From: Anna Tidey
Sent: 05 February 2026 12:17
To: [REDACTED]
Cc: Emily Wade; [REDACTED]
Subject: RE: DM/25/3101 & DM/25/3102 - Discharge of conditions application/ Variation of condition application - Blackbirds, Bramble Hill, Balcombe

'Rear and side single storey extension, front porch extension, changes to fenestration and render to upper parts.'

'Variation of condition No: 2 relating to DM/25/0873 to allow for minor changes to the overall design which include rear extension parapet roof additional of roof glazing in the side extension and enlarged porch extension with open gable.'

Submitted front door layout detail
Submitted 05.06.2025

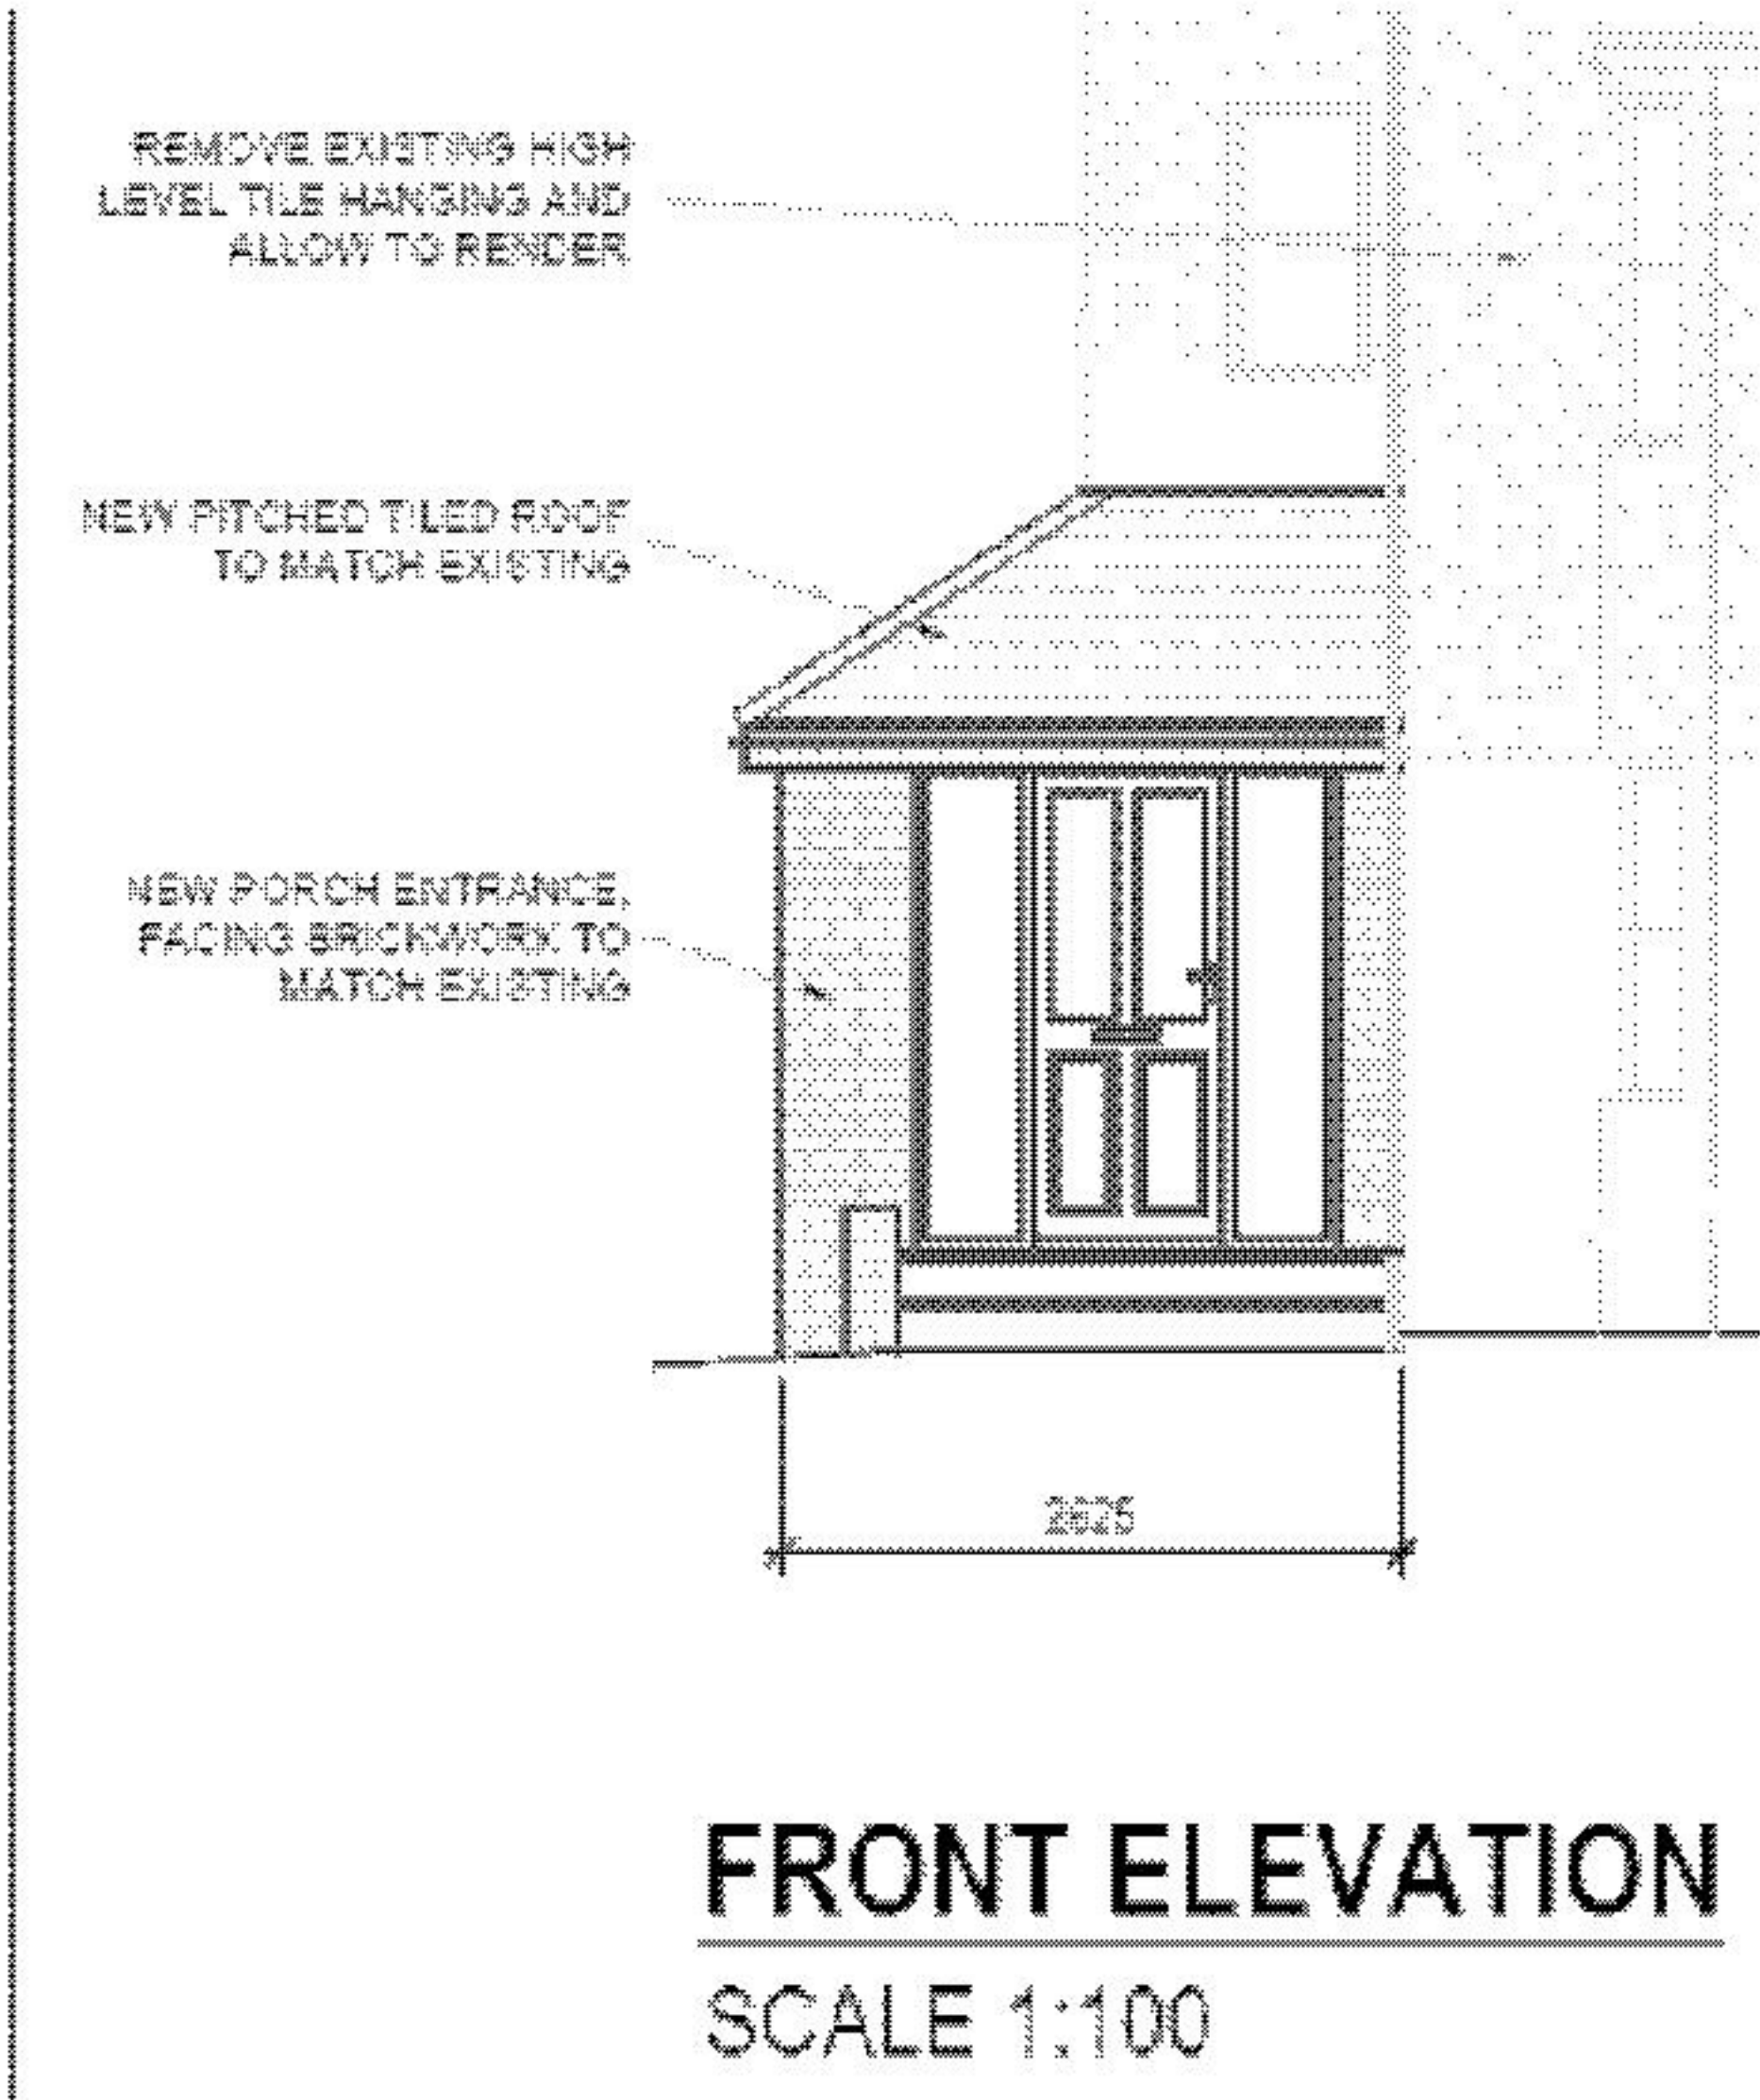
Thank you for your email regarding **DM/25/3102 - Discharge of conditions application**, the content of which I will review with Emily Wade. I note that the submitted front door detail does not correspond to the door design/glazing layout as shown on Proposed Floor and Elevations Plan No1252-02 Rev 05, as approved under DM/25/0873, see copied images below:

The submission of material details for discharge should accord with the Approved Plans showing the design which is to be implemented. A decision will not be made on this application as I have made the application INVALID pending further information on this point.

You may wish to await approval of amended plans ahead of applying for the discharge of the materials condition. Please can you confirm if the front doorway is to be amended to that shown on Proposed Plans & Elevations Drawing No 02, Rev 8, as submitted under DM/25/3101?

The front doorway is to be amended to that shown on Proposed Plans & Elevations Drawing No 02, Rev 8, as submitted under DM/25/3101. Please advise the best way forward regarding the validation / approval of each application.
